REF: RESUBMITTAL OF GRADING AND DRAINAGE PLAN FOR LEAD/ADAMS APARTMENTS AT 317 ADAMS SE (K17-D28) RECEIVED JULY 19, 1984

REF: GRADING & DRAINAGE PLAN FOR LEAD/ADAMS APARTMENT COMPLEX (K-17 D28) RECEIVED JUNE 25, 1984.

TITLE: CURB PENETRATION LEAD/ADAMS APARTMENT COMPLEX 317 ADAMS STREET S.E.

TITLE: CURB PENETRATION
LEAD/ADAMS APARTMENT COMPLEX
317 ADAMS STREET S.E.

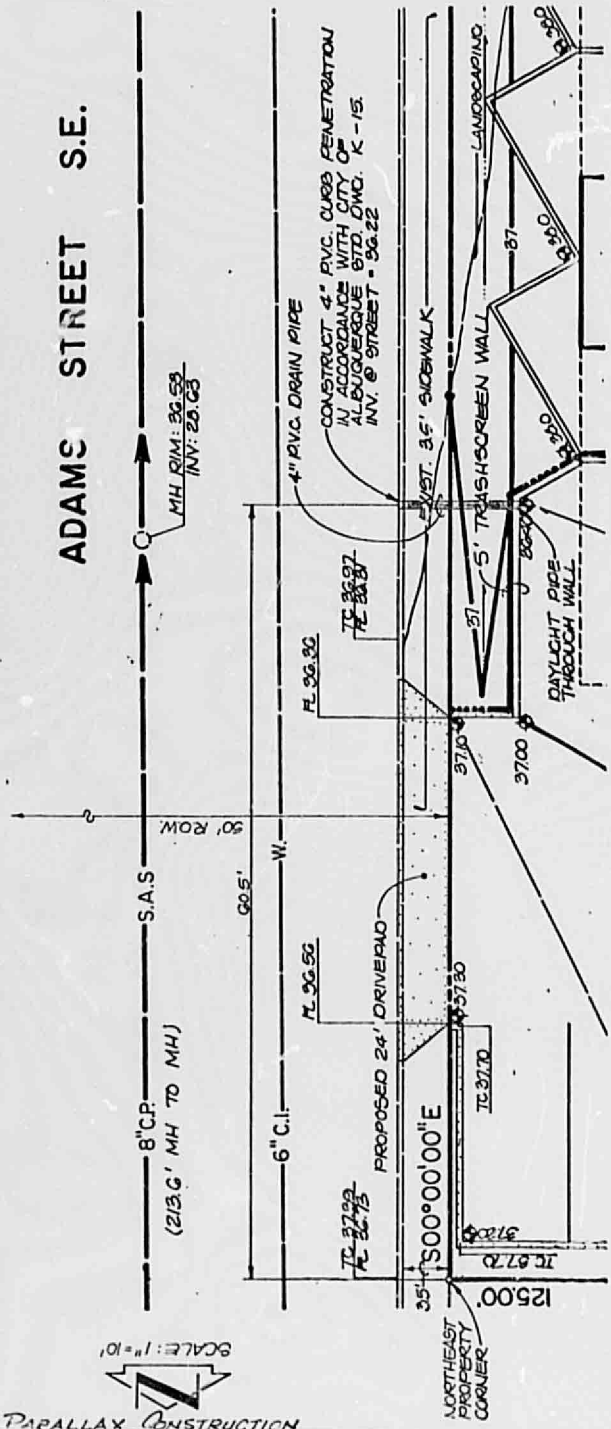
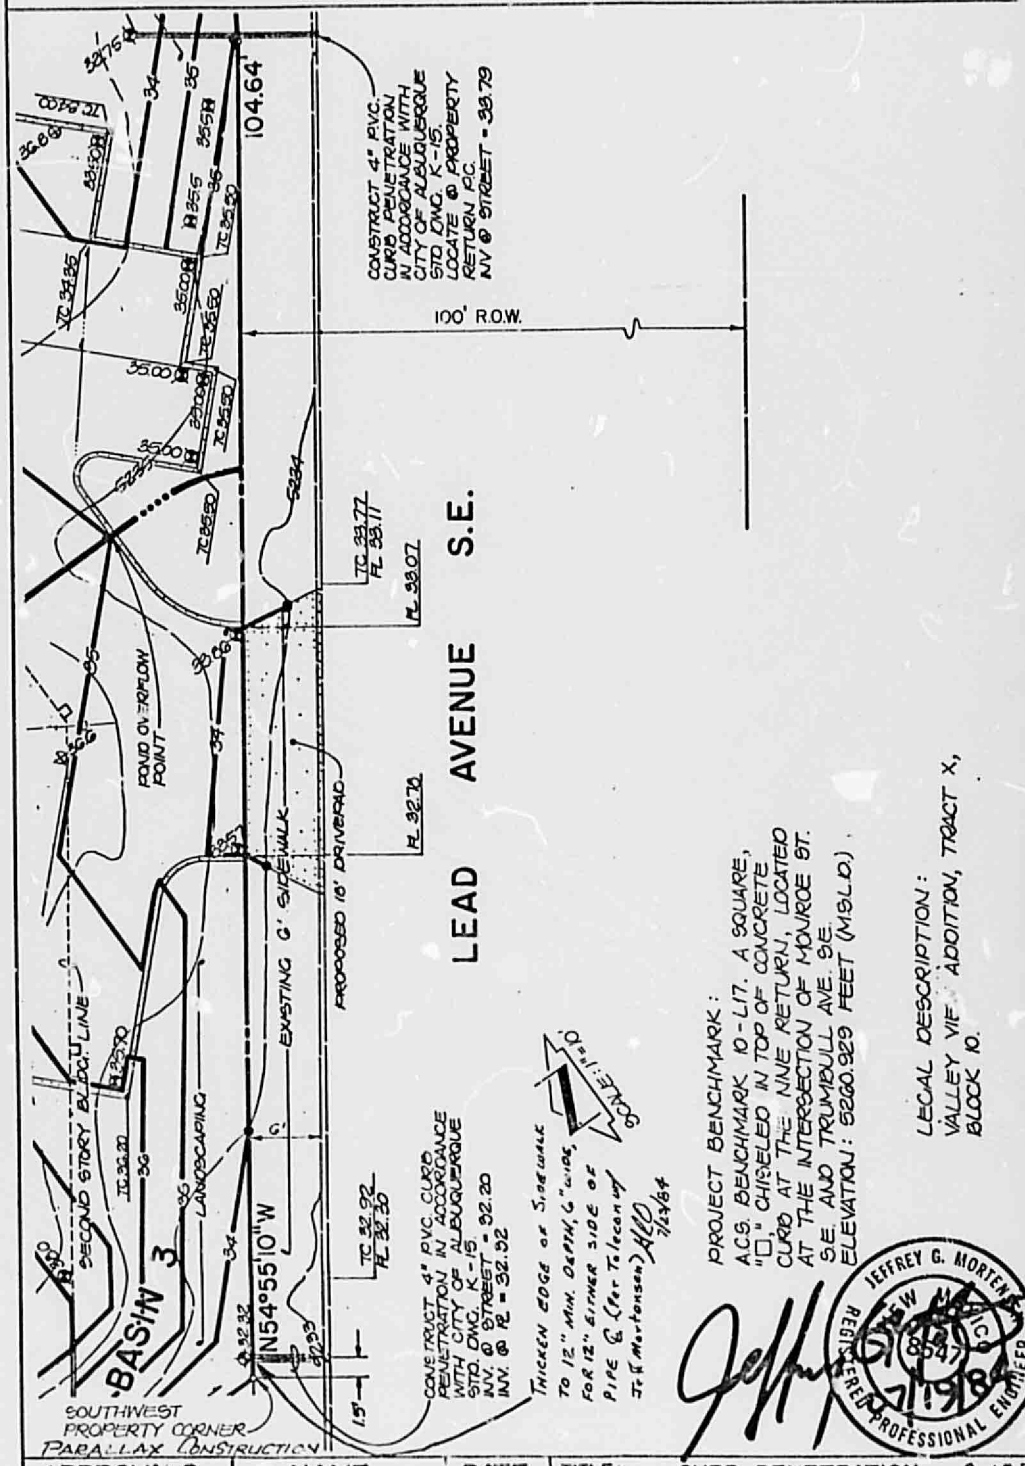
1. The bottom of basin 1 is not defined. Require bottom spot elevation or contours.

2. Explaination of how runoff will exit between the proposed building and the new garden wall.

3. Unable to follow the 5235 contour at basin 2. The contour ends at a curb 180 feet northwest of the 4" P.V.C.

4, Please explain in more detail the "pond overflow point" at the proposed Lead Ave. drivepath.

5. Does the 4" P.V.C. on the southwest corner of the site have enough capacity to eliminate flows over the existing sidewalk.

6. Correct the Q release formulas in the calculations.

7. What are the depths of flows in Adams St..

Thank you for spending the time with me yesterday to discuss your comments from you letter dated July 17, 1984 concerning the subject project. Based upon our discussion, the only item left for me to address was the corrections to the calculations. In particular, the addition of the square root symbols, the acreage designation for Basin 2, and the deltas for the Q_{100} and V_{100} calculations in the comparison between the existing and developed conditions. I have addressed these comments and I am now resubmitting for review and approval. Also attached is another drainage information sheet for this resubmittal.
